Sumi Apparels (Pvt) Ltd. #9920
Disari Poly Print & Packaging Ind. Ltd.
Disari Washing Plant

17.APRIL.2014

Identified Priority 1 Concerns

Priority 1 Concern

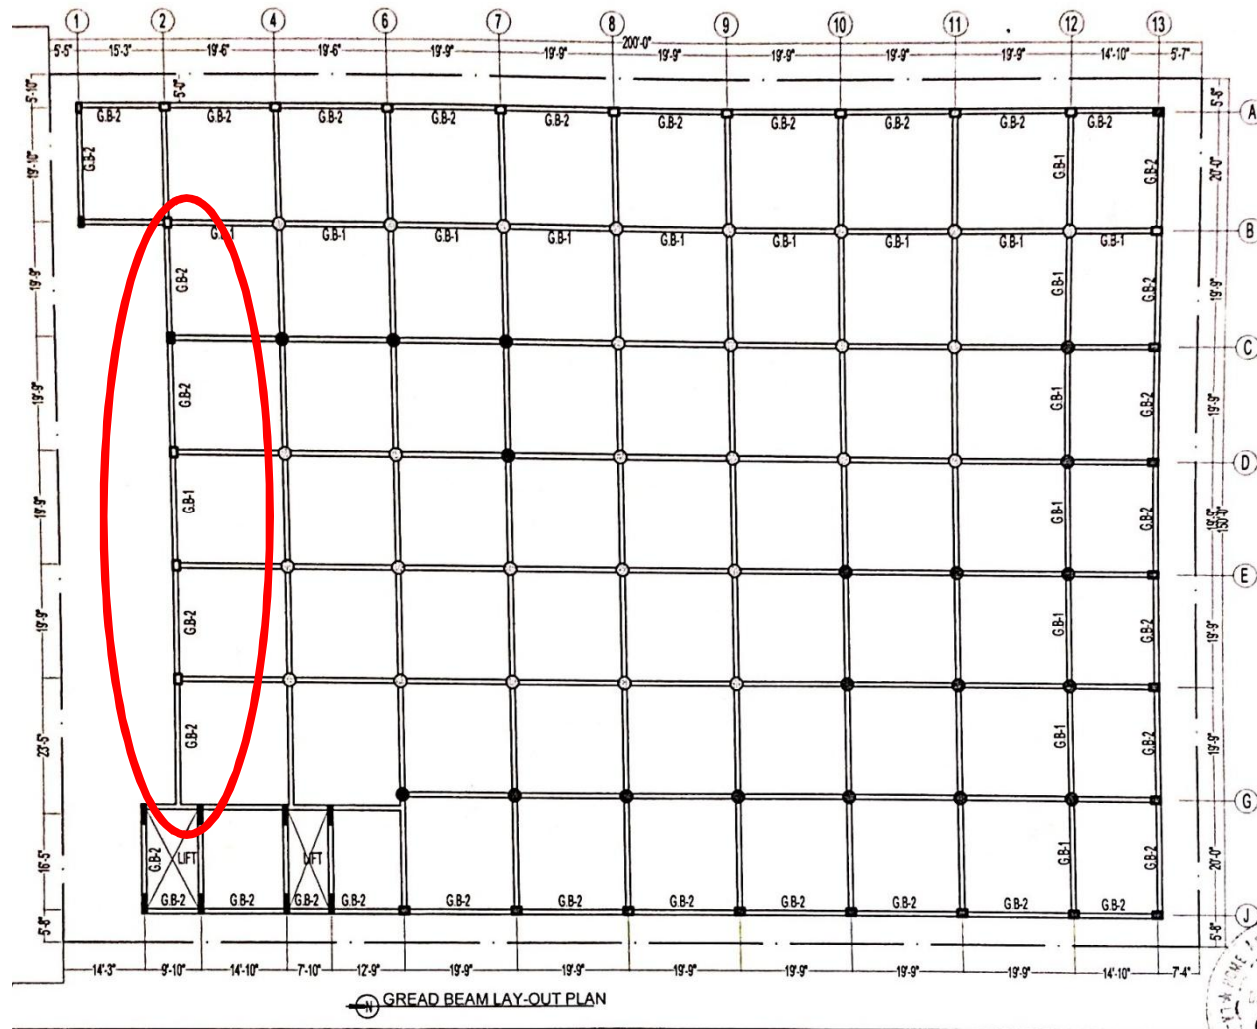
Structural drawings do not match current state or permit drawings. Cantilevers not shown. A courtyard shown on the permit drawings has been built over.

Major Concern

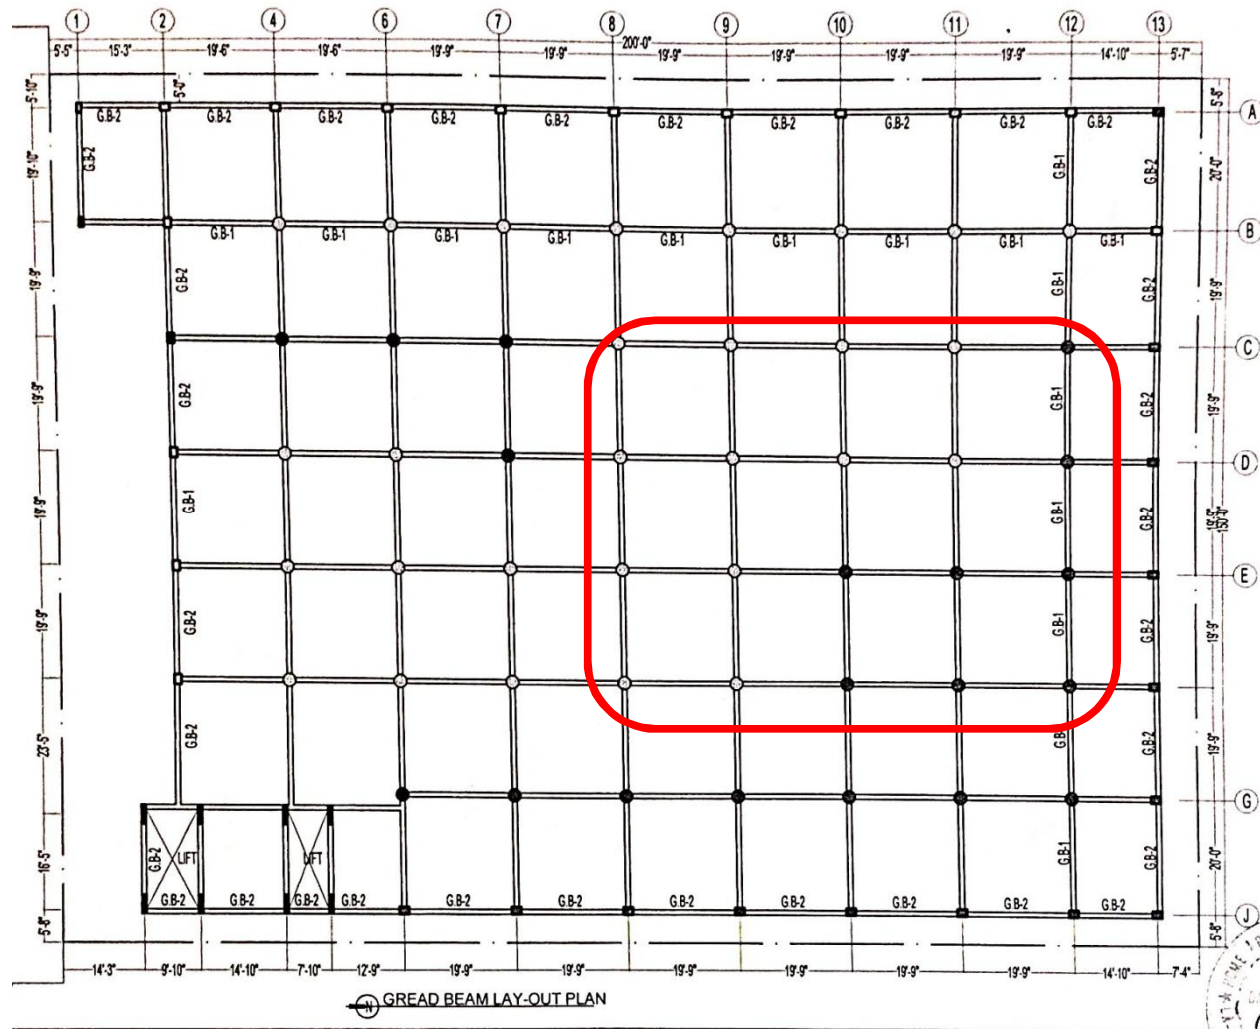
Structural drawings do not match current state or permit drawings. Courtyard shown on permit drawings has been built over. The two existing mezzanines are not shown on the permit drawings.

High storage loads on two floors. The rolls of yarn were calculated as 12kPa.

3rd Priority 1 Concern

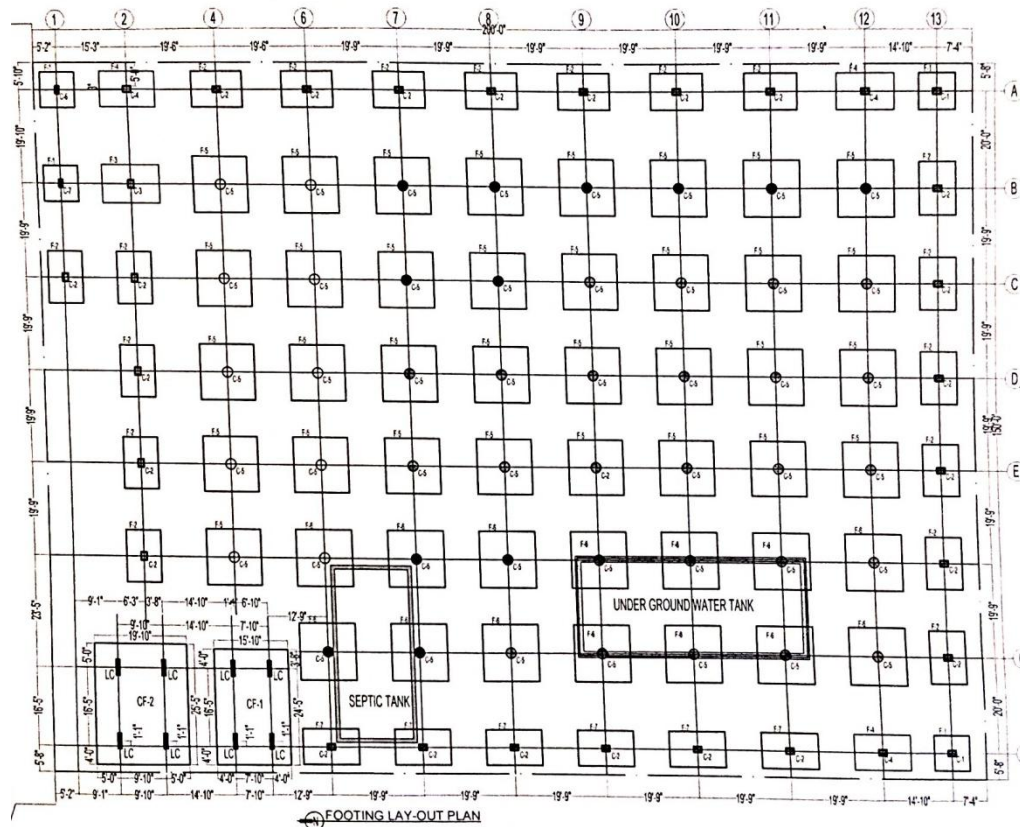
Cracking in beams, slabs and one isolated crack in column. Cracks are shown in red for clarity
